JRPP No:	2010NTH023
DA No:	DA0081/2011
PROPOSED DEVELOPMENT :	Major Retail Premises (comprising supermarket and three retail tenancies), associated car-parking and Subdivision to create one new lot, Lot 1 DP 534154, Lots A & B DP 398476, Lot 6 DP 230958, Lots 51 & 52 DP 710142, Lot 467 DP 871160, Lot 16 DP 758951, Lot A DP 339895, Lot 18 DP 758951, Lot B DP 396828, Lot 244 DP 1014012, Lot 42 DP 708583, Marius Street, Hill Street and Peel Street, Tamworth.
APPLICANT:	Hill Lockart Architects
REPORT BY:	Lucy Walker, Senior Development Assessment Planner Alison McGaffin, Director, Environment, Planning and Economic Development

Assessment Report and Recommendation

Application Number:	DA0081/2011
Application is for:	Major Retail Premises (comprising supermarket and three retail tenancies), associated car-parking and Subdivision to create one new lot.
Owners' names:	Charlie One Pty Limited Mr DJ & Mrs DR Bath Tamworth Regional Council
Applicant's name:	Hill Lockart Architects
Lodgement date:	26 August 2010
Statutory days:	40 days
Land/Address:	Lot 1 DP 534154, Lots A & B DP 398476, Lot 6 DP 230958, Lots 51 & 52 DP 710142, Lot 467 DP 871160, Lot 16 DP 758951, Lot A DP 339895, Lot 18 DP 7

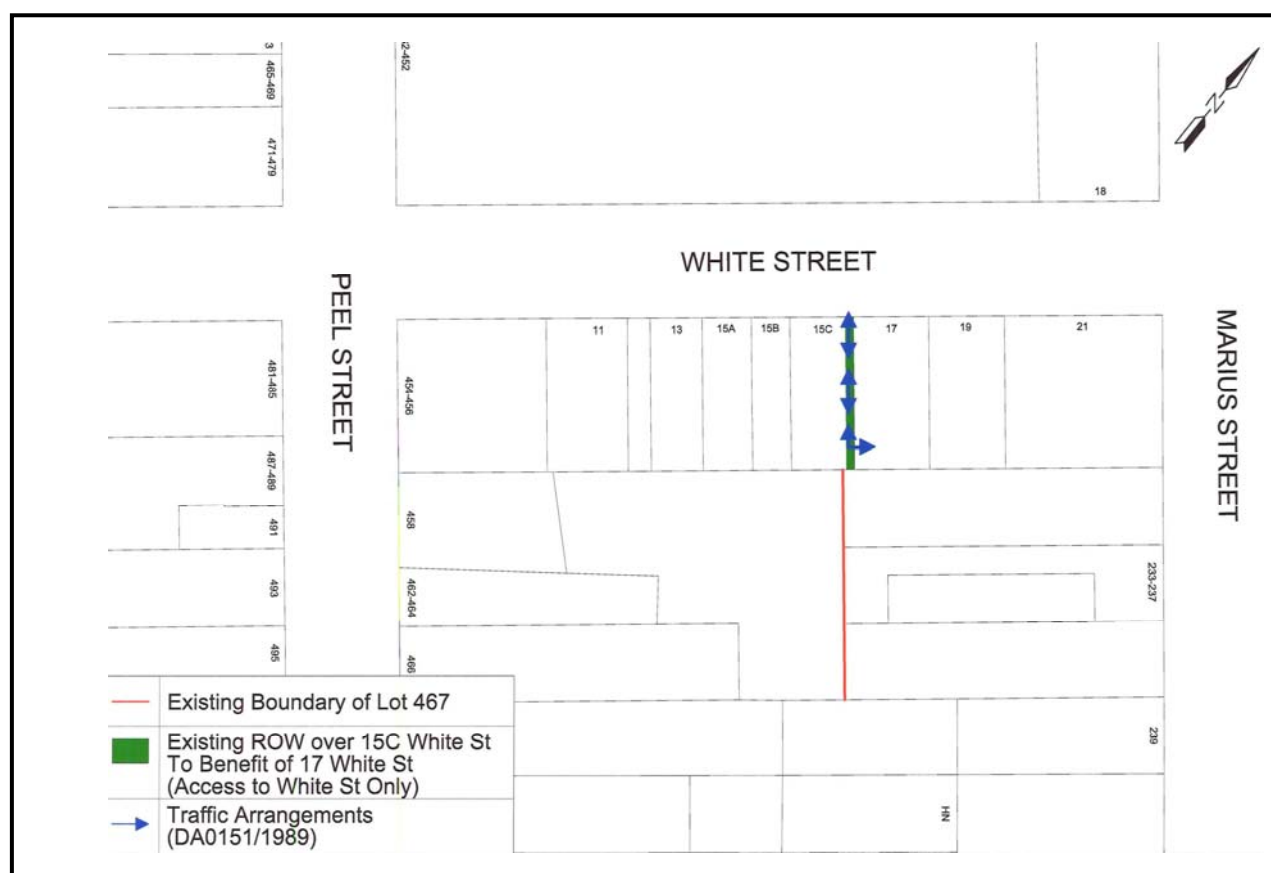
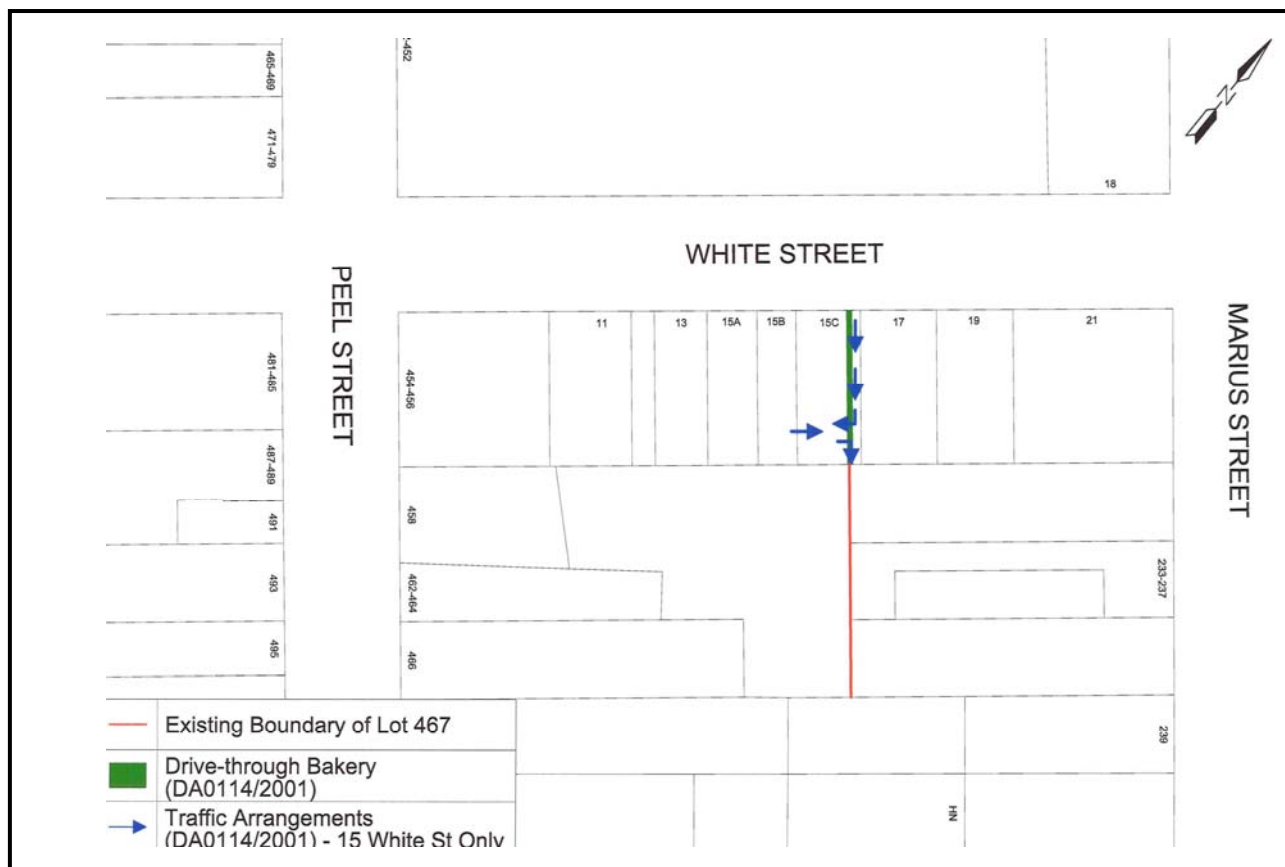
- ✂ *The right-of-way from White Street has not been considered in the proposal and is inadequate for traffic associated with the proposal.*
- ✂ *Access is required for 15, 17 and 19 White Street to the right-of-way to Marius Street and Council should negotiate access to the right-of-way to Marius Street for 17 and 19 White Street. Access to the right-of-way to Marius Street for 15 White Street may be affected by the development.*

The development does not rely on any right-of-way to or from White Street. The matter of vehicle and pedestrian access between the adjoining White Street properties and the existing rights of carriageway to Marius and Peel Streets have been raised in a number of public submissions.

Properties at 17 and 19 White Street do not currently have a legal access through the right of carriageway that runs at the rear of these properties up to Marius Street.

If such an access is to be obtained the respective owner may negotiate with the land owner of the development site to secure legal access to the right-of-way and then seek the approval of Council to modify any existing development consents which currently do not provide for a legal right of access between these White Street properties and the land at the rear. Any such application will need to address the traffic implications of this arrangement.
